C&R Consulting Pty Ltd (C&R) recently completed various environmental studies to support an environmental authority (EA) application for the recommencement of operations at Dianne Copper Mine (DCM), located within the Cook Shire on the Cape York Peninsula in north Queensland, about 130 km northwest of Cairns and 100 km southwest of Cooktown. It is noted that the existing EA (EPML00881213, dated 31 July 2023), covering six separate mining leases, has not undergone a significant amendment in several years, with the locations of approved, historical works not well defined under the EA.

The EA amendment application was submitted to the Department of Environment, Tourism, Science and Innovation (DETSI) on the 24 February 2025. Subsequently (27 June 2025), DETSI provided DCM with a request for further information regarding the proposed EA amendment and the associated progressive rehabilitation and closure plan (PRCP) schedule.

Table 1: Information requests and responses relating to the Environmental Authority.

Figure 1: Flow depth recorded at downstream South Creek over the 2024-2025 wet season in (a) November to December (2024), (b) December (2024) to January (2025), (c) January to February (2025), (d) February to March (2025) and (e) March to April (2025).

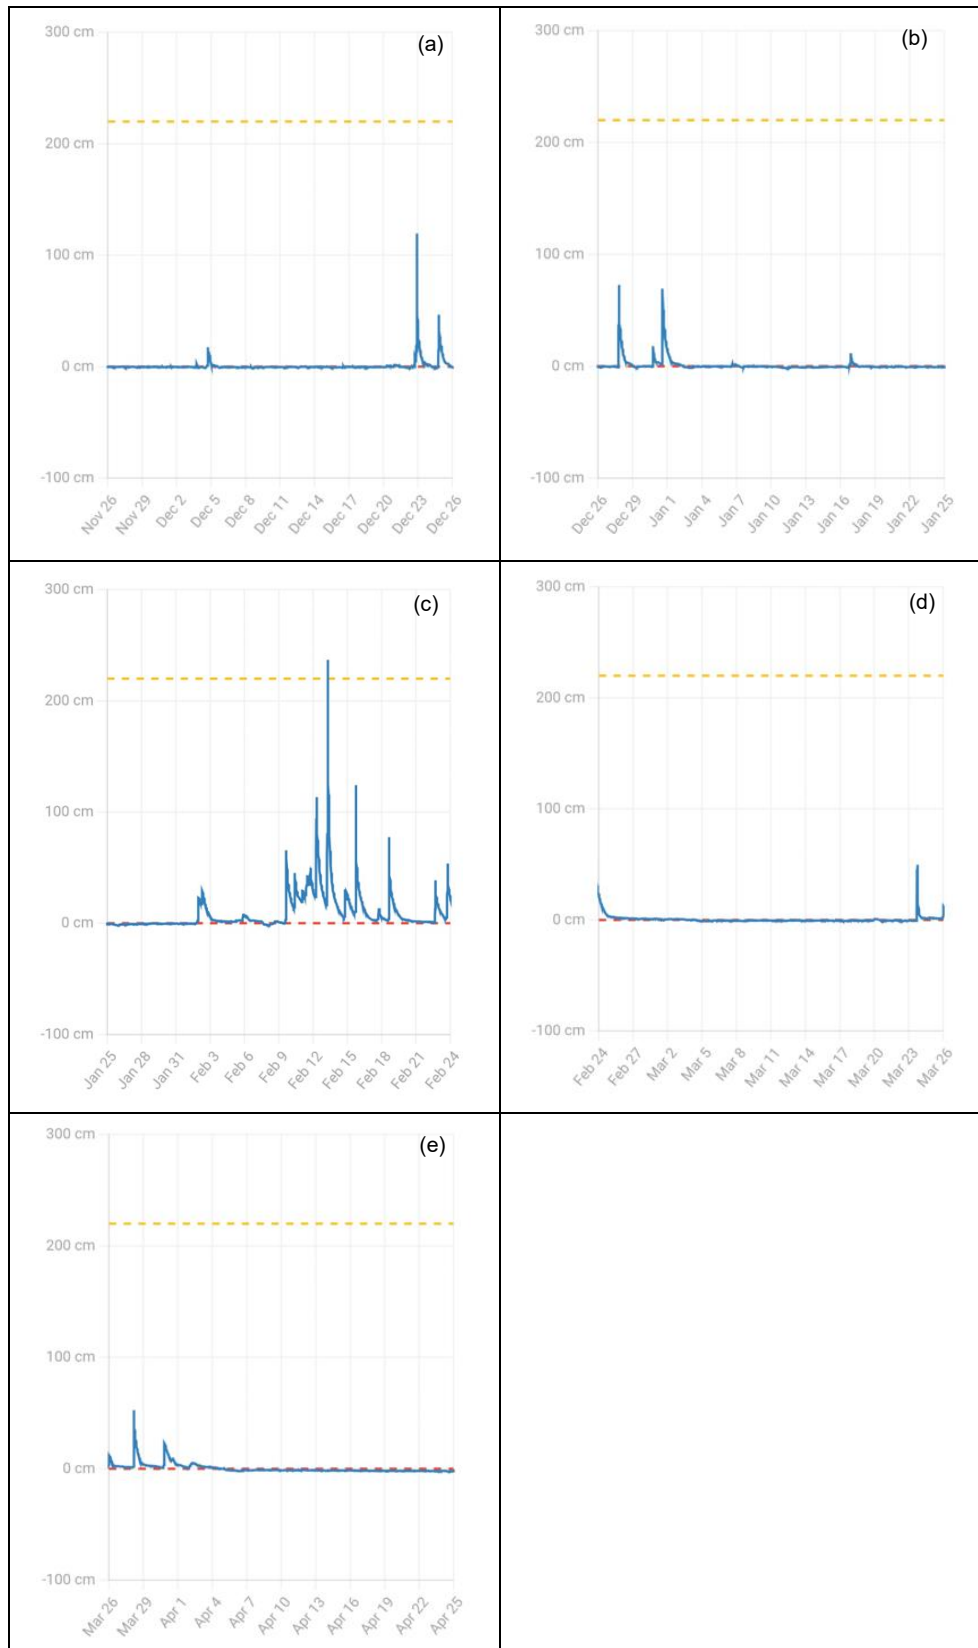
Item	Reference	Matter	Information Request	Response
	Amendment Application Environment Assessment Report	once sufficient data has been collected, which is expected to occur in 2024. The data from the first and second sampling events from 2024 have been included, but data points are insufficient to establish site-specific surface water trigger values.		
EA7	Appendix 3 Dianne Copper Mine Groundwater and Surface Water Impact Assessment Report	There are no groundwater dependent ecosystems identified through the standard mapping systems. However, the presence of regional riparian vegetation communities (with greater zones around Gum Creek) that rely on the ephemeral watercourses suggests that there may be indirect groundwater dependence. The deep-rooted Melaleuca and Eucalyptus would tap into shallow water tables and perched aquifers.	Provide an assessment of seasonal surface water persistence and potential baseflow contributions to the Regional Ecosystems within and surrounding the site.	The climate at Dianne Copper Mine is characterised by extended dry periods (May–October) with no stream flow, and wet seasons (November–April) with sustained rainfall and consistent flows. Waterways associated with the project site are either ephemeral or intermittent dependent on their connectivity to groundwater seeps. South Creek (also called Gum Creek tributary) flow data from the 2024–2025 wet season (and detailed in C&R (2025)³ shows short flows occurred throughout the wet season, with most events occurring between November and February (Figure 1, attached to this letter). These short peaks reflect rainfall events within the upper catchment area. The data suggests that the system is ephemeral, with flows quickly falling back to zero following the cessation of the corresponding rainfall event (Figure 1). However, due to the natural shifting of the low-flow channel within the creek bed caused by high seasonal flows, baseflows may often be missed by the gauge, suggesting the system should be considered intermittent. During the updates of the water management system for the project, including remediation of the Settling Dam, both the flow gauges will be reviewed and if necessary, repositioned for the project. In parallel, the

Item	Reference	Matter	Information Request	Response
				setting in the creek of the flow gauges will be investigated to see if they can be lowered in the channel. It should be noted that it is only low flow events that the existing flow gauge location in the creek does not pick up, and during these low flow events, a release from the Settling Dam (Release Dam) is extremely unlikely. Prior to the availability of flow data (pre-2024), photographic and visual evidence was utilised (Table 2) and indicated that the system was intermittent, with baseflows persisting in the system for extended periods (up to 1 month) following rainfall runoff flow events. These extended baseflows are expected to be related to groundwater seeps in the upper catchment area. Additionally, due to the presence of bedrock throughout South Creek's reaches pooled water can persist throughout much of the year (i.e. up to $\frac{3}{4}$ of the year) at various locations.

Figure 2: Map of watercourses and drainage features as assessed by on site ground truthing.

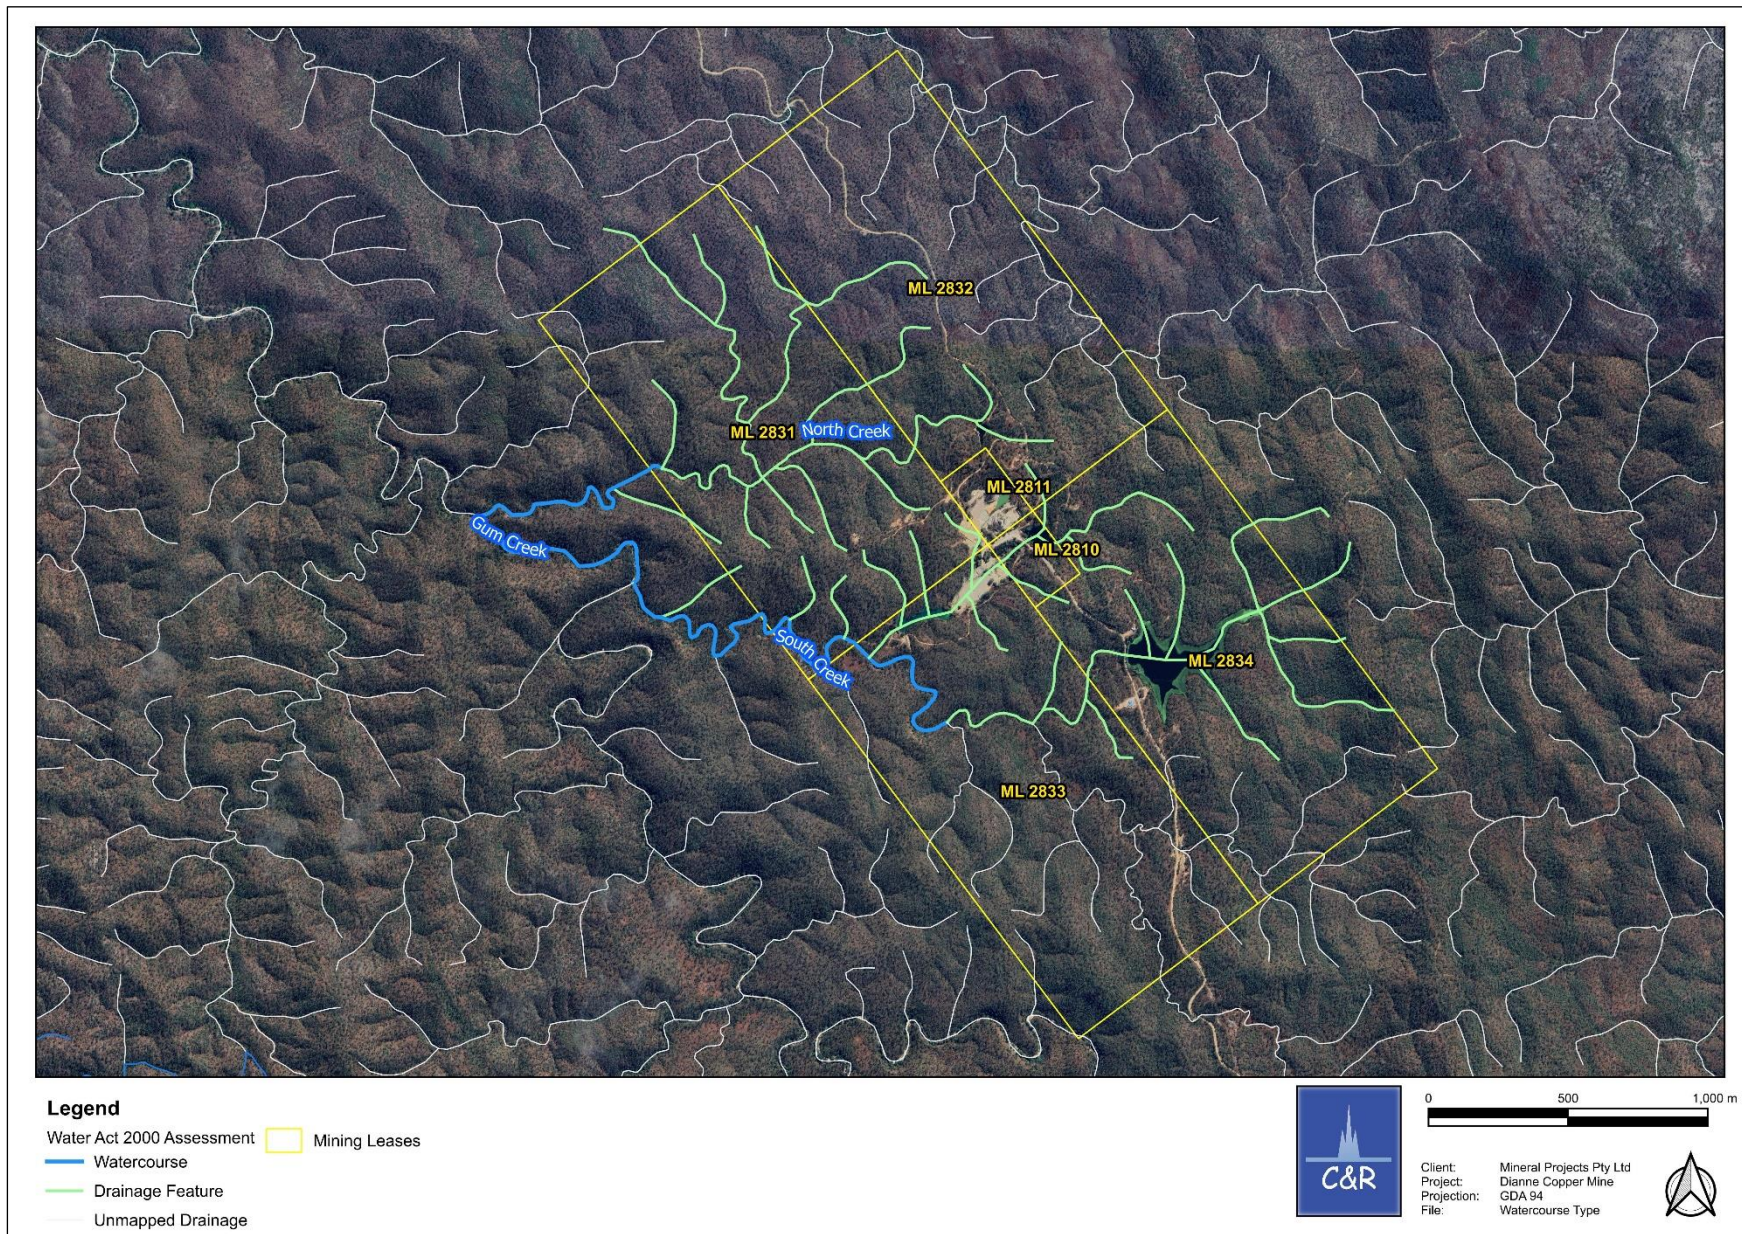
EA12/PRCP6	Dianne Copper Mine Recommencement Project Environmental Authority Amendment Application Environment Assessment Report	The application does not contain information on temporary/permanent watercourse diversions, however they are expected to be required based on this information provided in the application. For example, the Heap Leach Pads are proposed to be in a valley where there would surface water control issues and heightened risk to receiving environment. Watercourse diversions should comply with the Department of Natural Resources, Mines and	Provide information regarding the proposed watercourse diversions planned and required for the project. Include information on: i) Provide information and drawings outlining the design of the water diversion(s), both permanent and / or temporary; ii) How any permanent watercourse diversion is to be designed and operated to ensure that it is stable, self-sustaining and does not impact on the adjoining	The Water Act identifies watercourses and drainage features on the Watercourse Identification Map (WIM). All of the watercourses associated with the project are charted under the WIM as 'unmapped'. The closest defined watercourse is the Palmer River, located approximately 3.5 km north of the project (in a straight line). The Water Act defines a watercourse as follows: 1) 'A <i>watercourse is a river, creek or other stream, including a stream in the form of an anabranch or a tributary, in which water flows permanently or intermittently, regardless of the frequency of flow events—</i> a) <i>in a natural channel, whether artificially modified or not; or</i> b) <i>in an artificial channel that has changed the course of the stream.</i>

Item	Reference	Matter	Information Request	Response
				sparsely encountered within the drainage line in proximity to the historical farm dams (i.e. around the margins or immediately downstream of the dams), suggesting the artificial permanency of water at these locations is sustaining the only true 'riparian' species within the system. Therefore, the lack of natural continuing flows to create a riverine environment provides further evidence that the unnamed tributary is a drainage feature rather than a watercourse. Based on the Water Act definitions of a watercourse and drainage feature and the onsite observations discussed above and in C&R (2024), the unnamed tributary (and associated tributaries) meets the criteria for classification as a drainage feature. Therefore, no diversions are required for the recommencement of operations at Dianne Copper Mine.
